0376-09-90-3

PROPOSED SWIM POOL FOR Mr A.R. FRYER  
 AT 62 HIGHLANDS ROAD ON SUB 1 OF SUB A  
 OF SUB 85 OF SUB C3 OF THE FARM  
 DUIKERMONTAIN No.785

**AMENDMENTS TO APPROVED PLAN NO. 478-S-84 AND PROPOSED VERANDAH FOR MR. A.R. FRYER 62 HIGHLAND ROAD GREENWOOD PARK.**

PLAN OF POOL 1:100

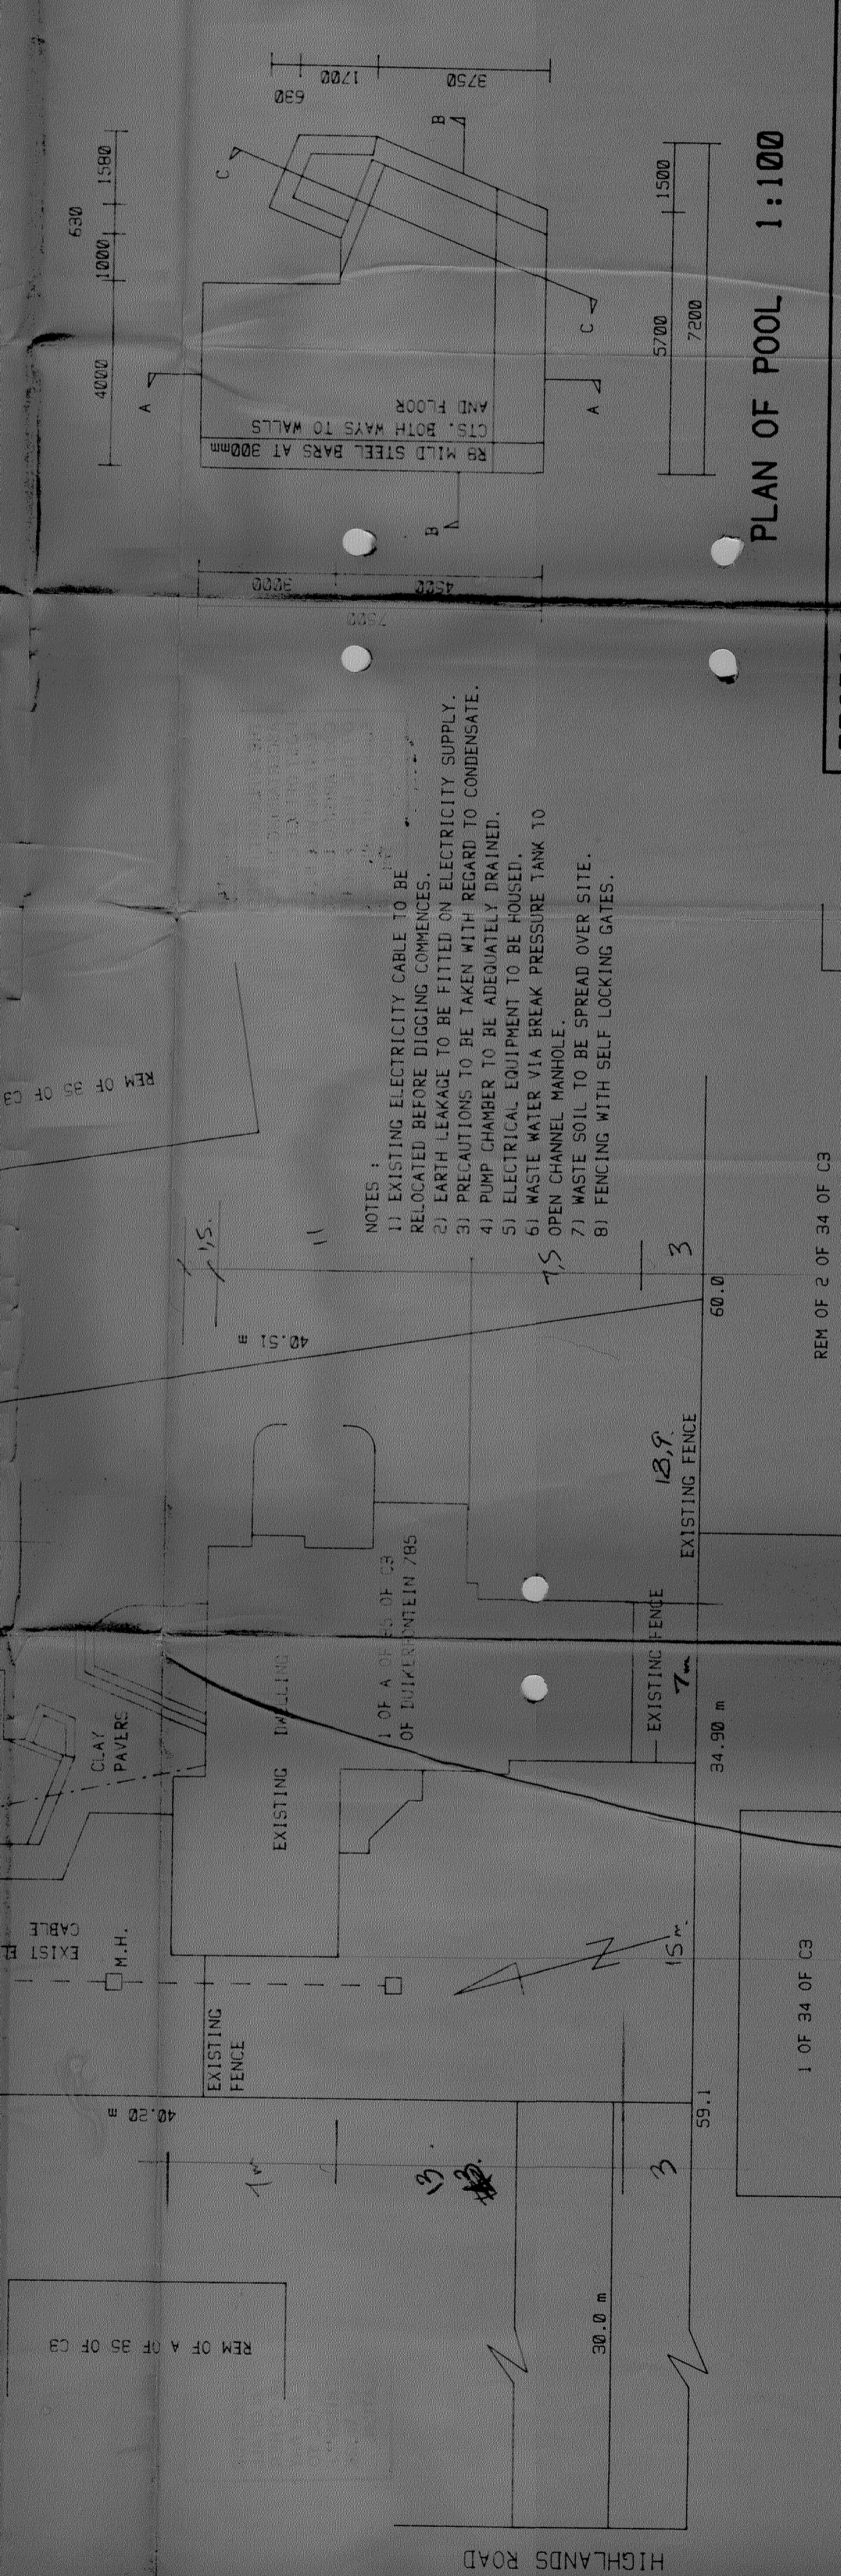
APPROVED SUBJECT TO FOLLOWING CONDITIONS:

THE POOL TO BE FINISHED AS REQUIRED IN ACCORDANCE WITH THE REGULATIONS OF THE NATIONAL BUILDING REGULATIONS PRIOR TO THE POOL BEING FILLED WITH WATER.
